Upgrade HVJB to Charger Harnesses

Classification	Repair Bulletin	Section/Group	44 - High Voltage System	Country/Region	Europe, APAC
Year	2012-2014	Model	Model S	Version	All

This Service Bulletin supersedes SB-14-44-003 R2, dated 30-May-14. Each content change is marked by a vertical line in the left margin. Discard the previous version and replace it with this one.

Figure 1 (Dual Charger configuration shown)

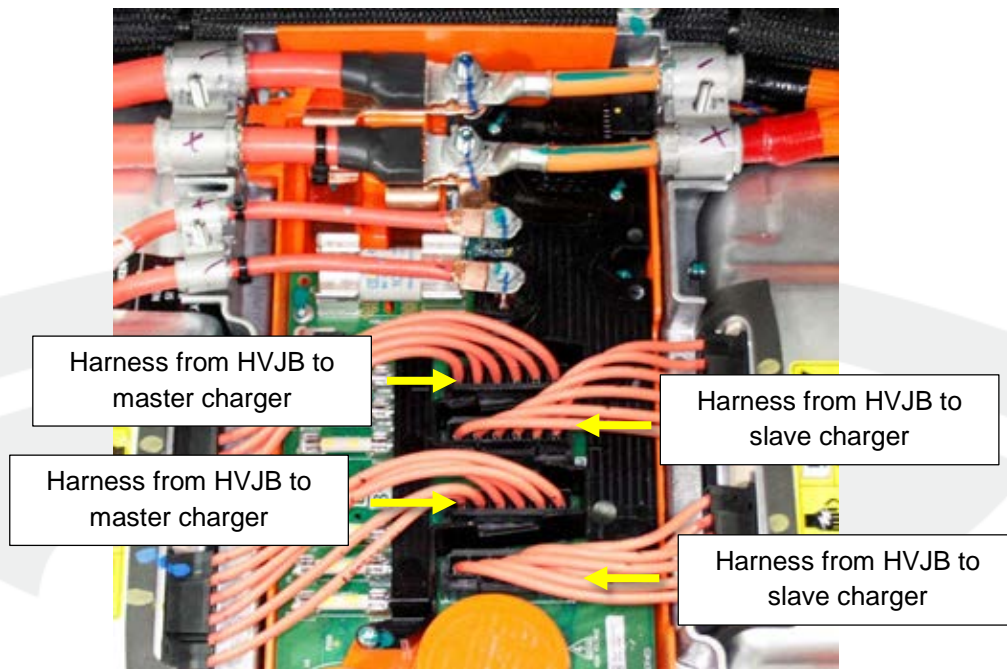
- Replace the 2 harnesses that connect the HVJB to the master charger (Figure 1). If the vehicle is equipped with dual chargers, also replace the 2 harnesses that connect the HVJB to the slave charger.

⚠ CAUTION: The harnesses for the different chargers are visually similar and have similar part numbers. Ensure that the correct harnesses are installed in the correct location. Note that the harnesses to the master charger are slightly longer than the harnesses to the slave charger.

✓ **Figure 2**

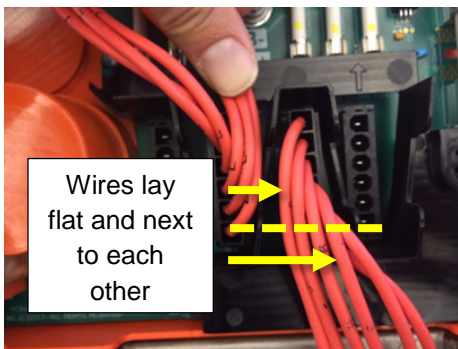
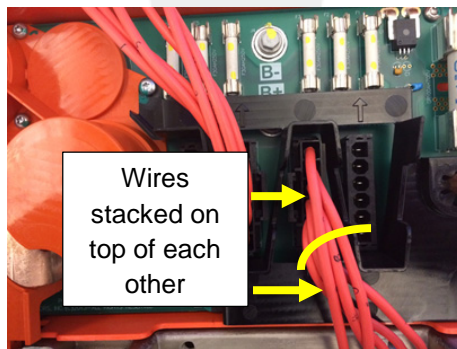
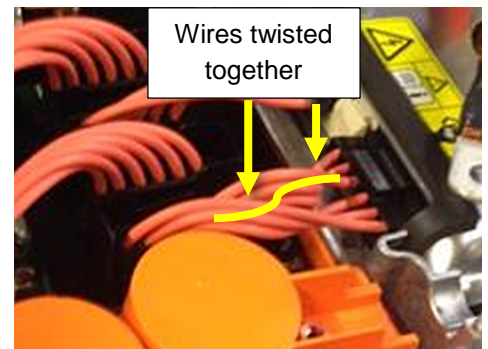
⚠ CAUTION: During installation, ensure that the harnesses are arranged neatly and are not twisted, and that they do not put unnecessary stress on the ports inside the HVJB or the charger (Figures 2–4).
